re: Geotechnical Review – Rear Yard Lot Terracing
Proposed Residential Development – Conservancy Lands East
Borrisokane Road – Ottawa, Ontario

file: PG5036-MEMO.40

Paterson reviewed the following drawings prepared by DSEL as part of the current memorandum:

- No. 20-1180 – Grading Plan – Sheet No. 93 to 94, Revision 15, dated May 24, 2024.

Project	PG5036 - Conservancy East, Borrisokane Road, Ottawa, ON		
Group	Figure 1A - Section A-A - Static Analysis		
Drawn By	MA	Company	Caivan Communities
Date	2024-09-25	File Name	Geotechnical Review - Lot Terracing

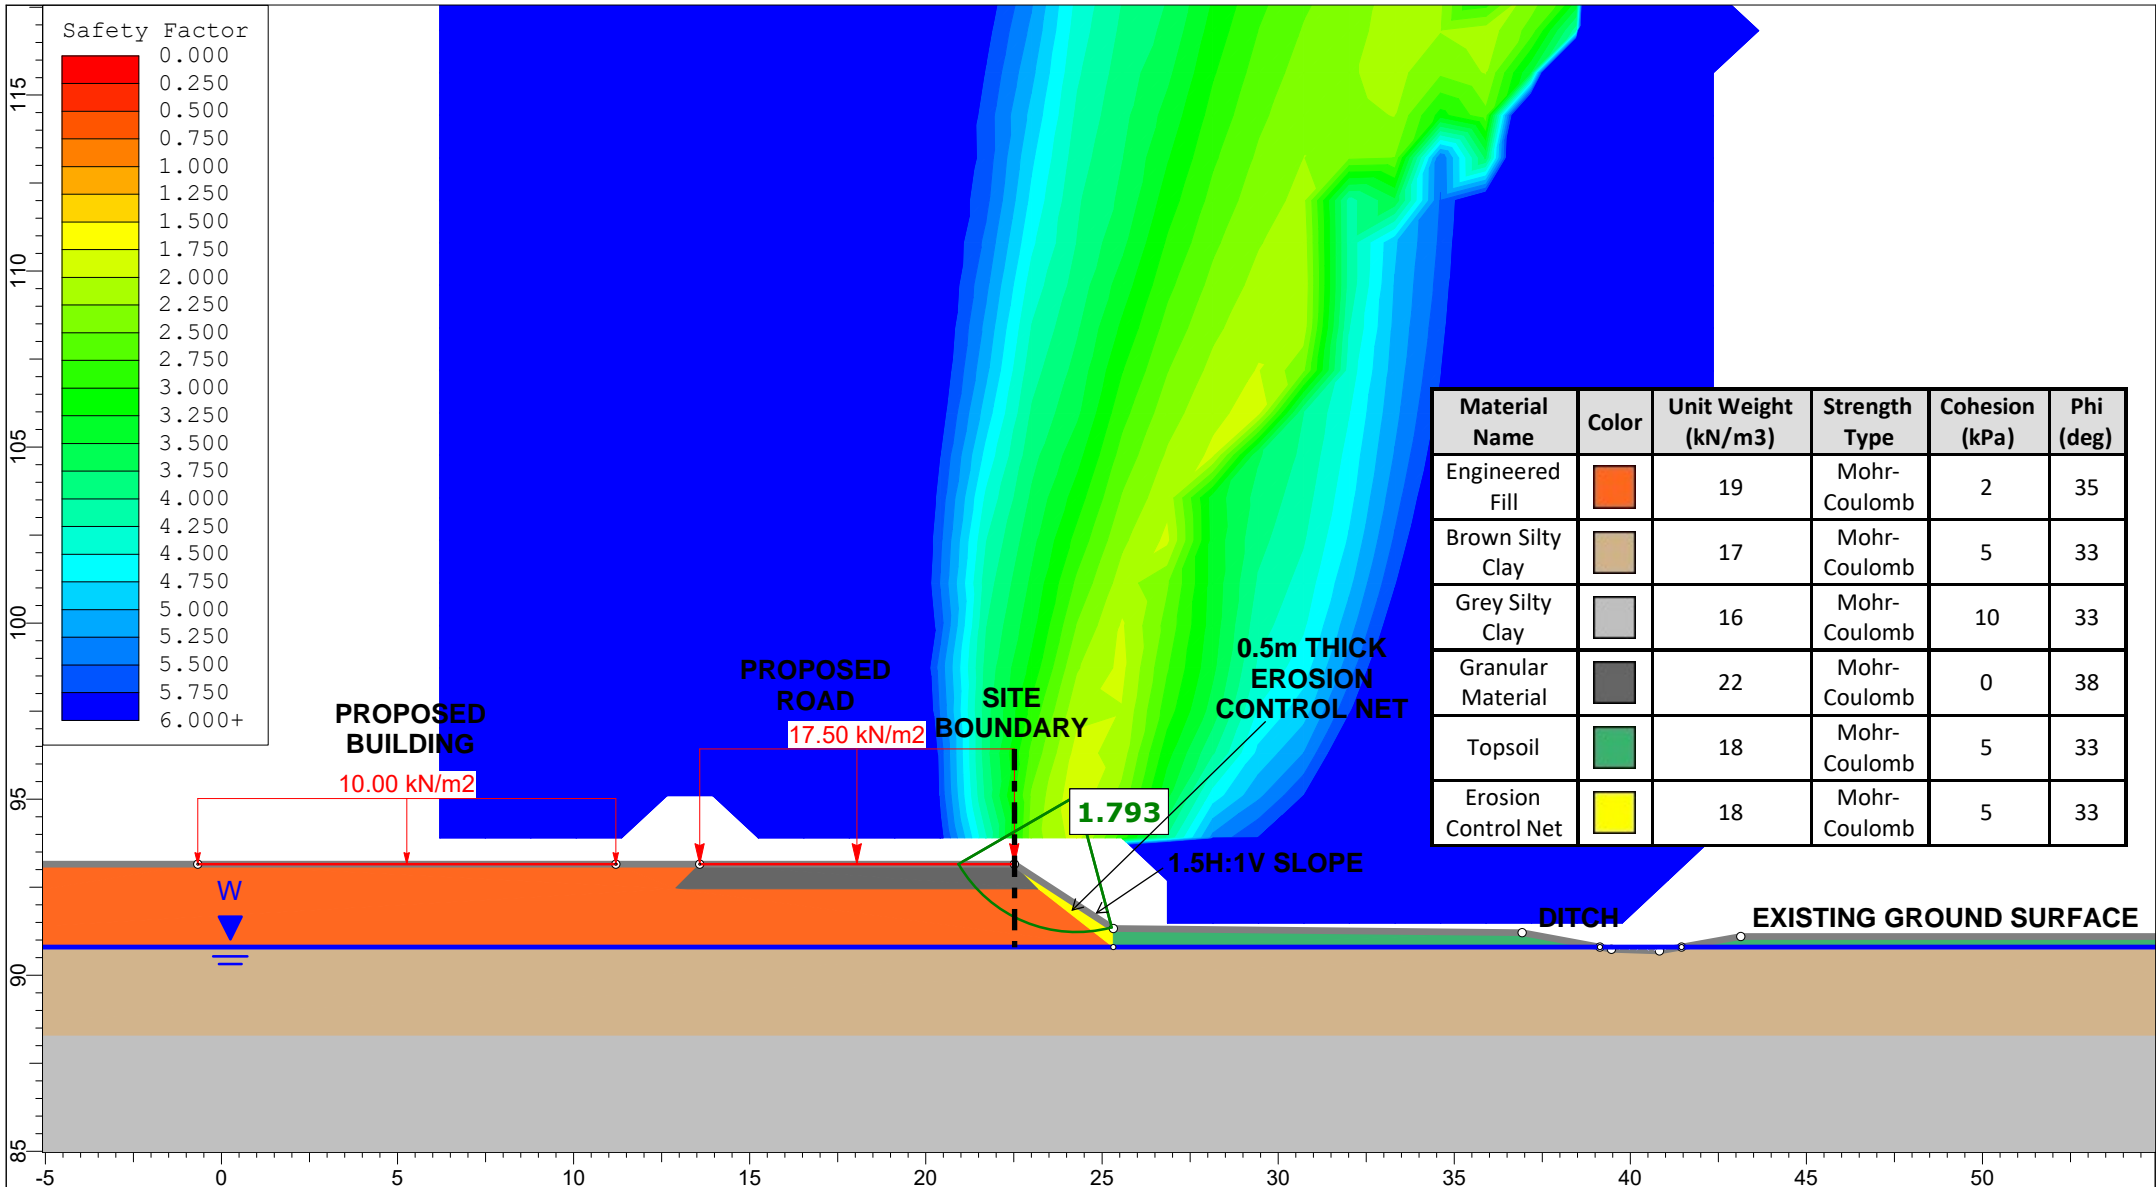
The results of the static analysis for Sections A-A and B-B are shown on Figures 1A and 2A, attached to the current memorandum. The results indicate the factors of safety for all locations exceed 1.5, based on a maximum 1.5H:1V slope, which is acceptable.

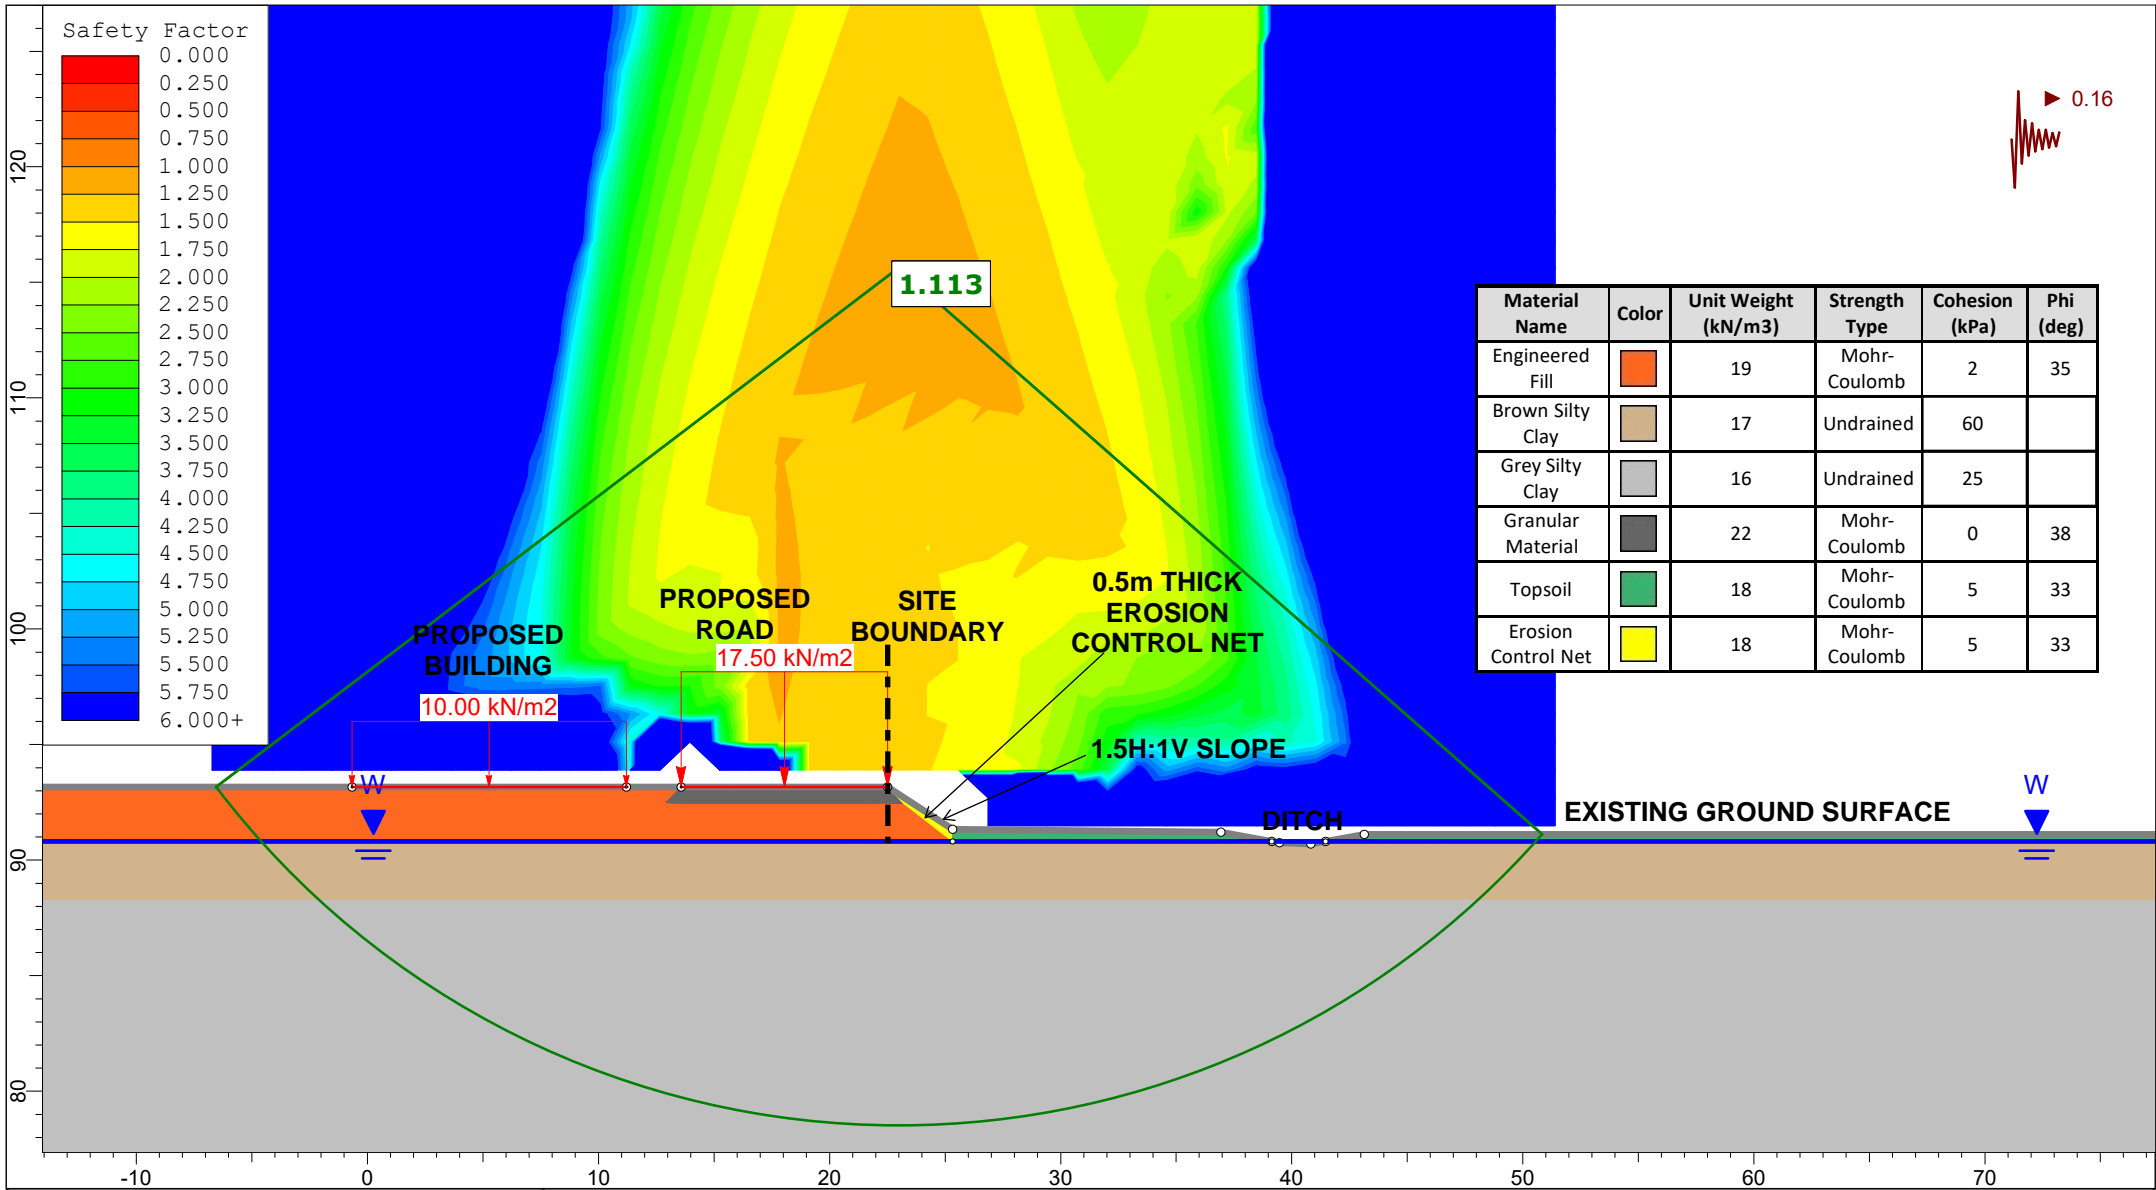
Analyses considering seismic loading were also completed. A horizontal acceleration of 0.16g, equivalent to 50% of the peak ground (seismic) acceleration (PGA=0.32g), was considered for the slope. The results of the seismic analyses are shown on Figures 1B and 2B. The results indicate that the factor of safety exceeds 1.1 for cross-sections A-A and B-B under seismic analysis conditions.

FIGURE 3 - PROPOSED TERRACING PLAN - SECTION A-A

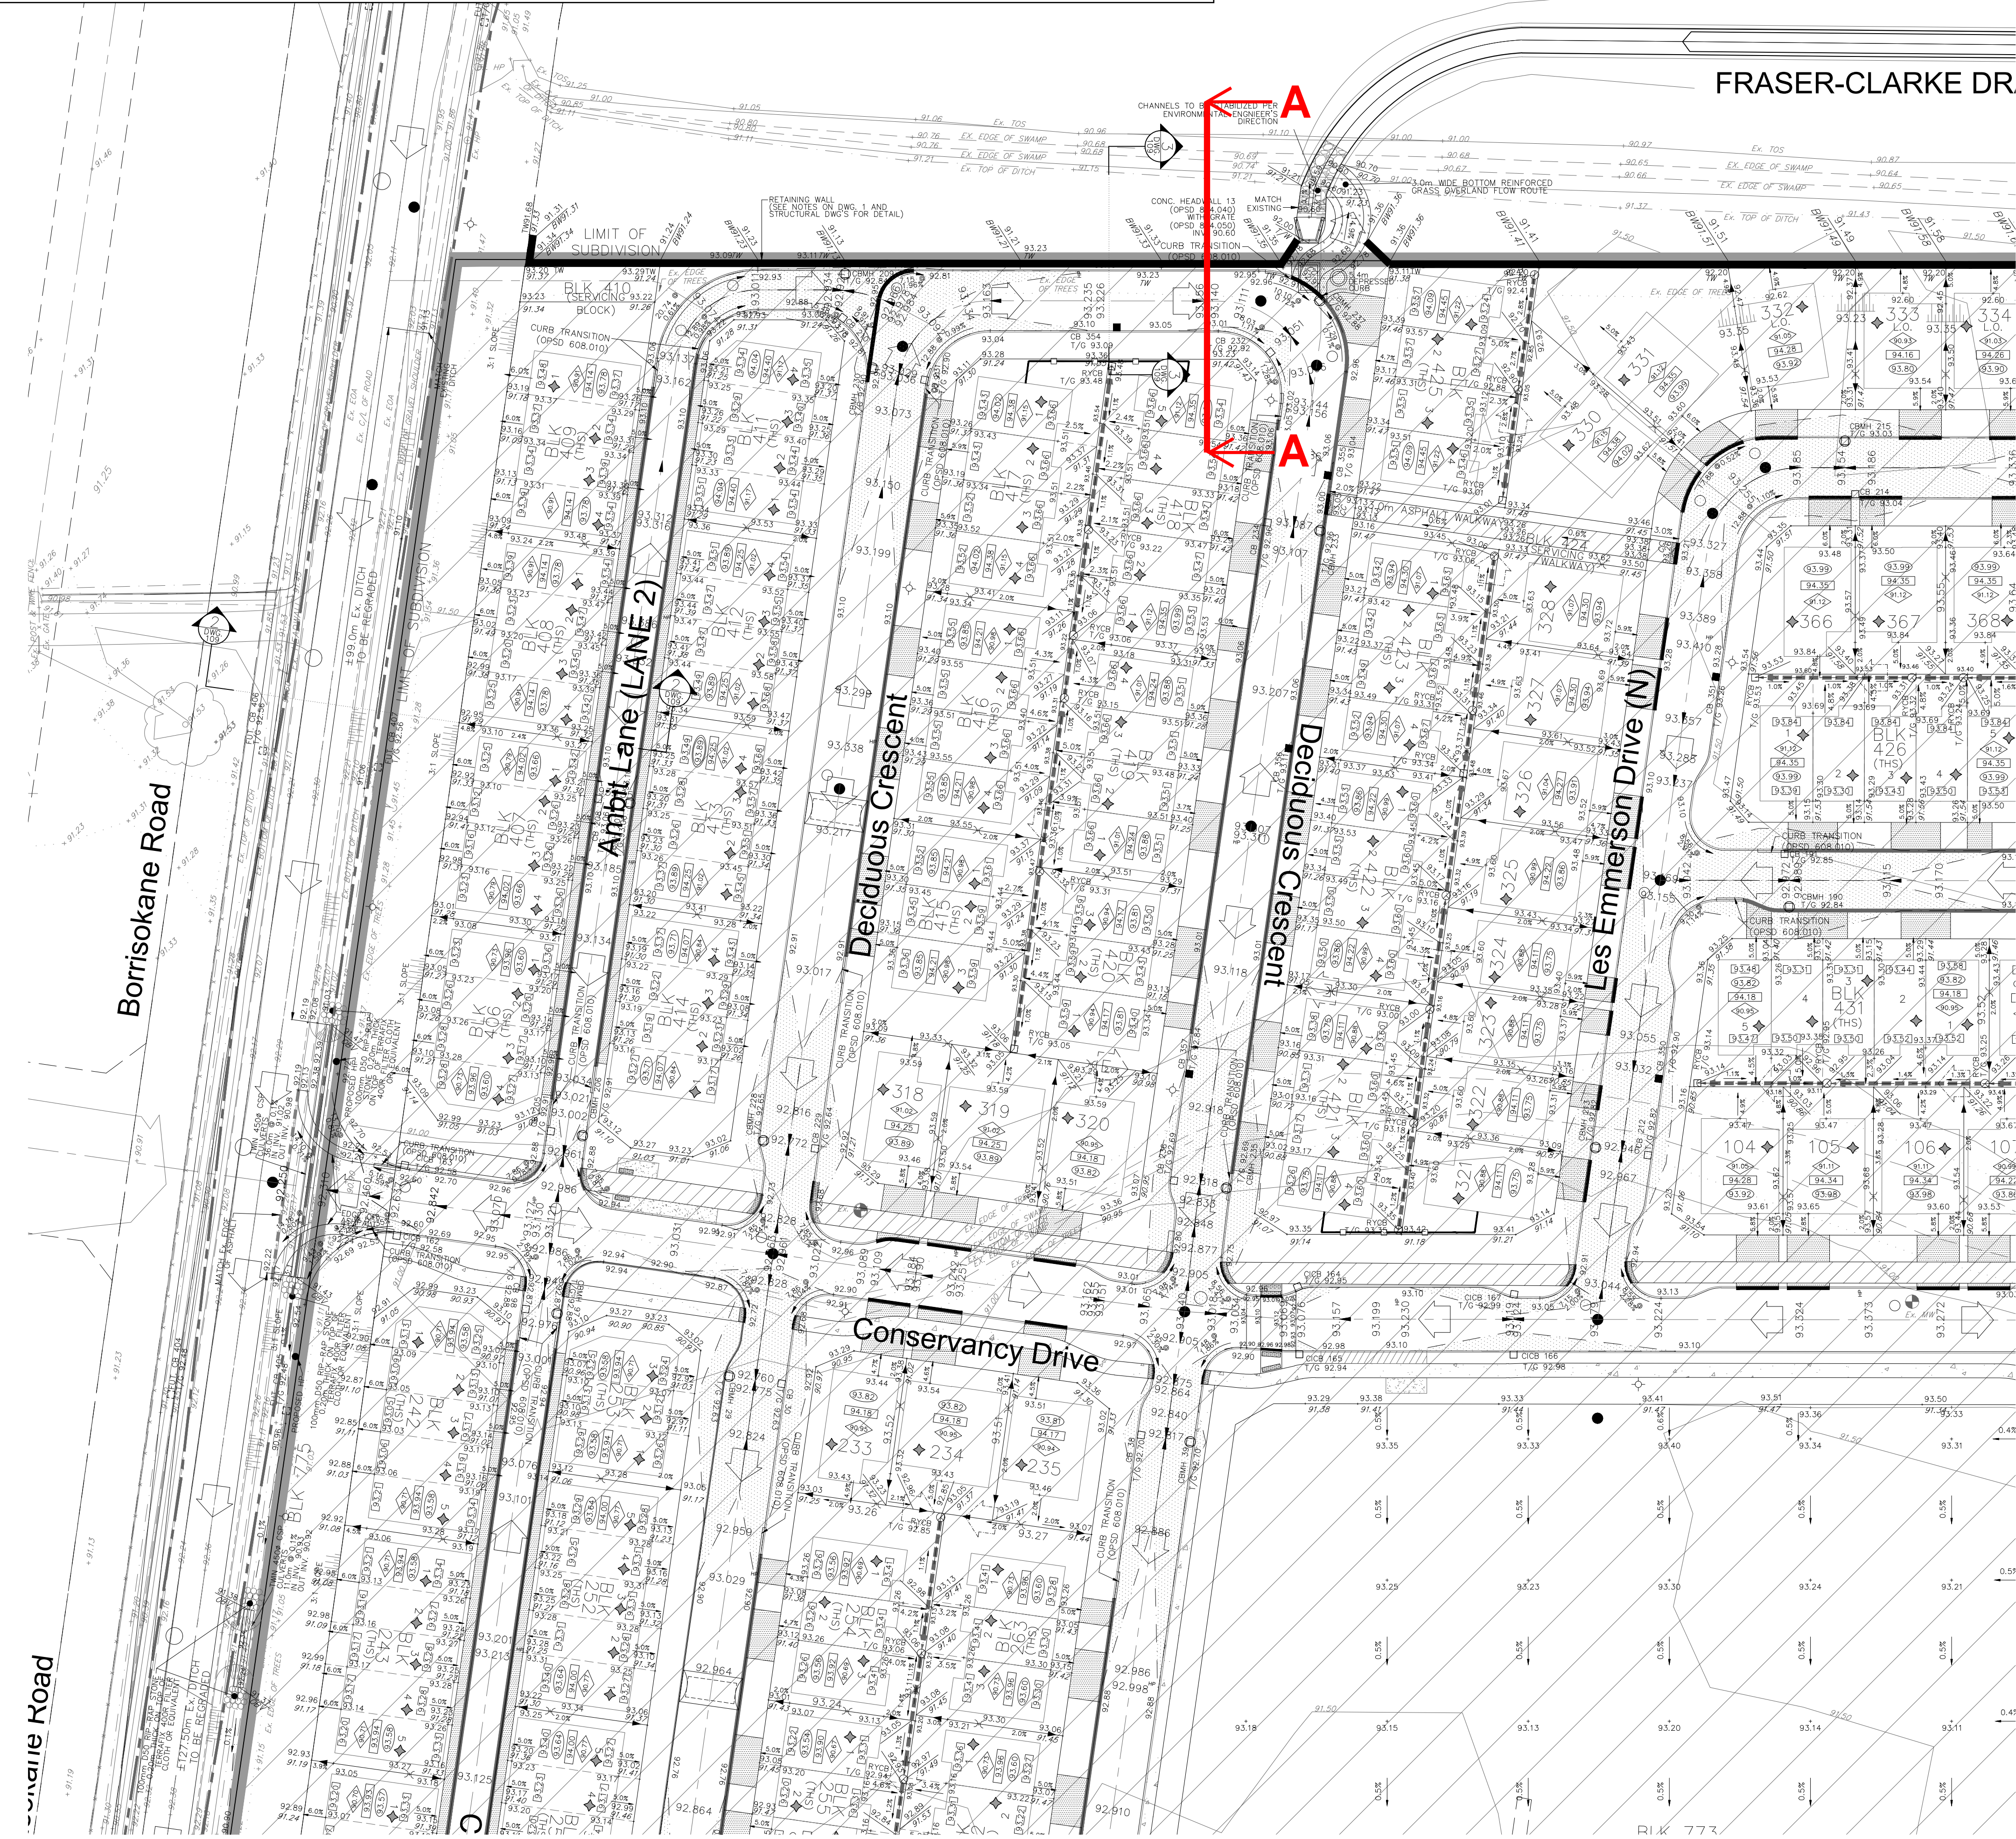
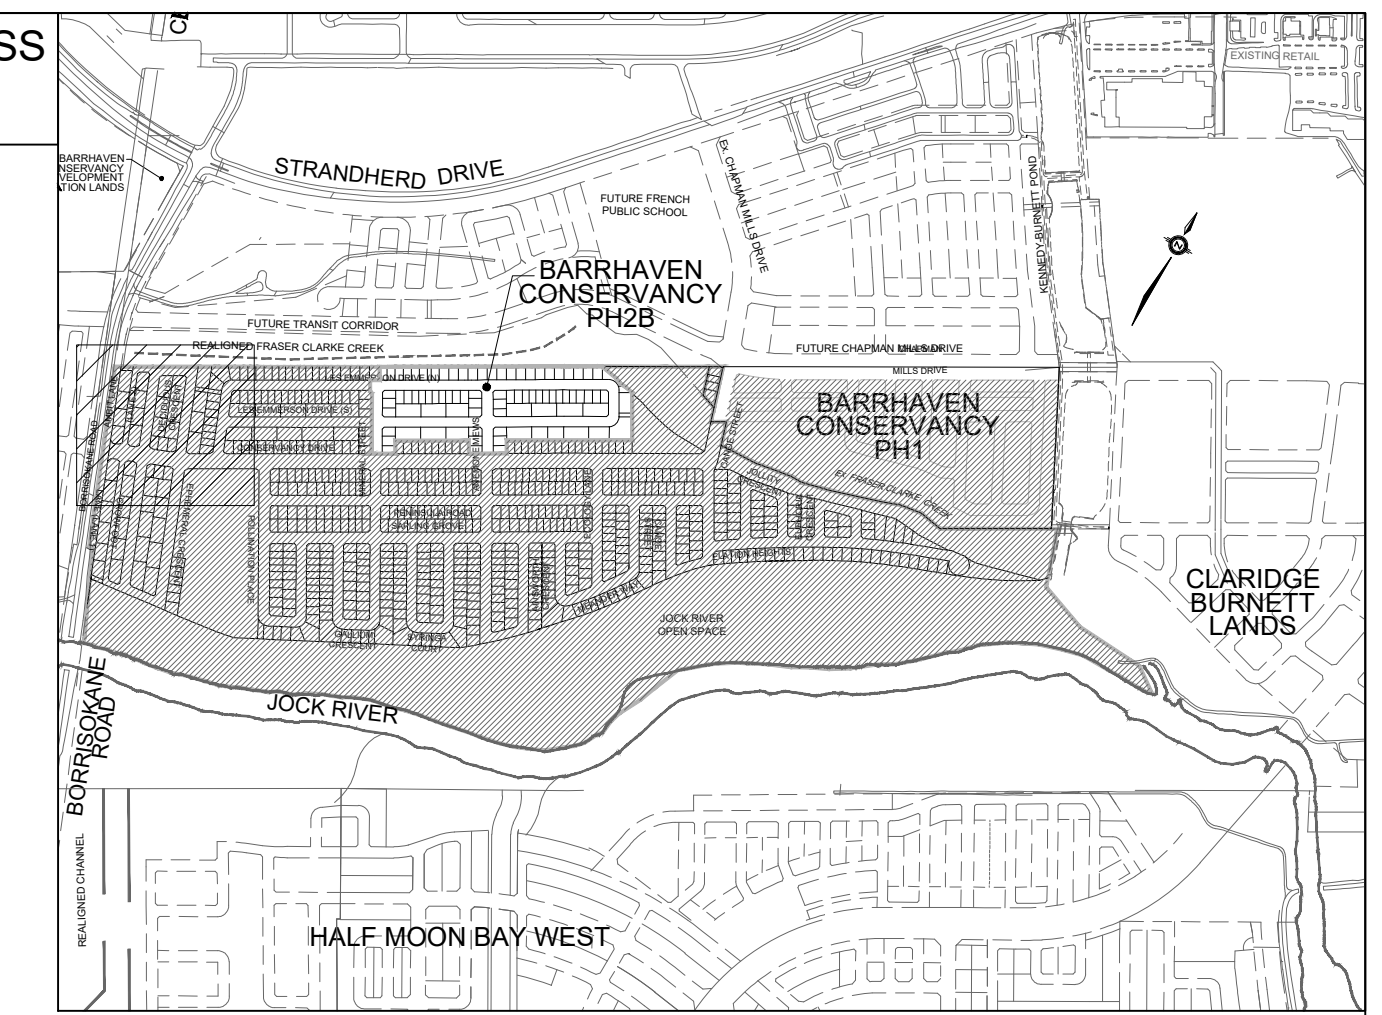
One (1) slope cross-section, representing a maximum 1.5H:1V, reinforced slope, was studied at each area in which terracing has been proposed. The cross-section locations (Sections A-A and B-B) are presented on Figure 3 and 4 – Proposed Terracing Plan.

The cross-sections were analyzed to determine if 1.5H:1V terracing could be supported at the subject site, taking into consideration proposed structures and the existing soil conditions.

The proposed terracing at the property boundaries is considered to be acceptable, from a geotechnical perspective. For permanent slopes with a 1.5H:1V slope profile, it is recommended that a nonwoven geotextile such as Terrafix 200r be placed over the engineered fill material located at the slope face, and beneath the topsoil and landscaping soils to promote long-term stability of the rear-yard slope face. The geotextile fabric should extend a minimum of 0.3 m beyond the top and toe of the slope face.

Further, an erosion control net, such as Fibramulch C32, or approved equivalent should be placed above the topsoil layer to prevent erosion of the slope while vegetation is established. The erosion control net should extend a minimum of 0.3 m beyond the top and the toe of the slope.
